DEPARTMENT OF PLANNING & ENGINEERING

****UPDATED** BZA Staff Report**

Re: Cases ZB 2019-09 (V) | 1795 N Morton St | Take 5 Indiana, LLC

Figure 1: Sight Visibility Triangles

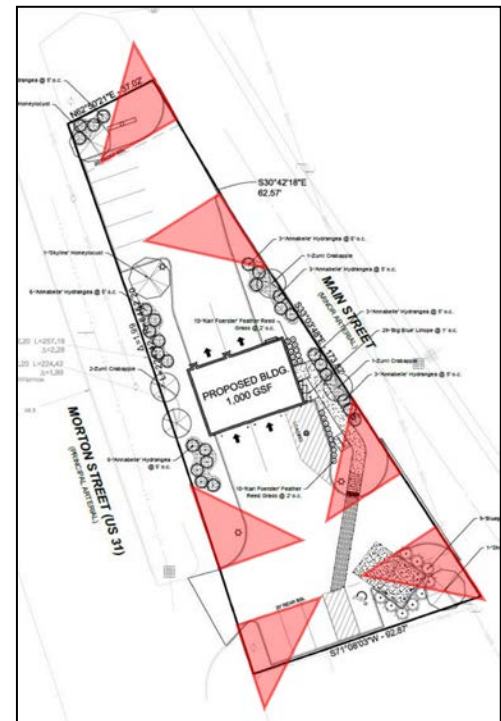
25. All proposed entrances intersect with an Arterial road; therefore, 35 foot sight visibility triangles are required at each entrance intersection. [See [Figure 1, REVISED](#) to the right]

26. Variance (10.): *Petitioner requests approval to be allowed encroachments into each of the sight visibility triangles.* [See [Exhibit B, page 10](#), [Exhibit D: Sign Package](#), and [Exhibit E: Revised Landscape Plan](#)]

- The entrance from N. Morton St. would have vehicles in parking spaces to the south. Landscaping has been revised and relocated out of visibility triangle to the north.

- The south entrance from N. Main St. would have landscaping and the dumpster enclosure to the south and landscaping at the farthest triangle point to the north.

- The north entrance from N. Main St. would have the pole sign encroaching at 8-11’ feet above grade, and the south would have landscaping at farthest triangle point away.

- a. All applicable federal, state, county, and local permits/approvals are required; including, but not limited to, Site Development Plan approval, Improvement Location Permits, and compliance with all building, fire, and health codes.
- b. Landscaping shall be planted per the revised landscape plan submitted August 5, 2019.
- c. Freestanding pole sign located within sight visibility triangle must be free of sign cabinets and/or decorative base between grade and 8 feet above grade.
- d. Directional signs must be setback at least 2 feet from all public rights-of-way.
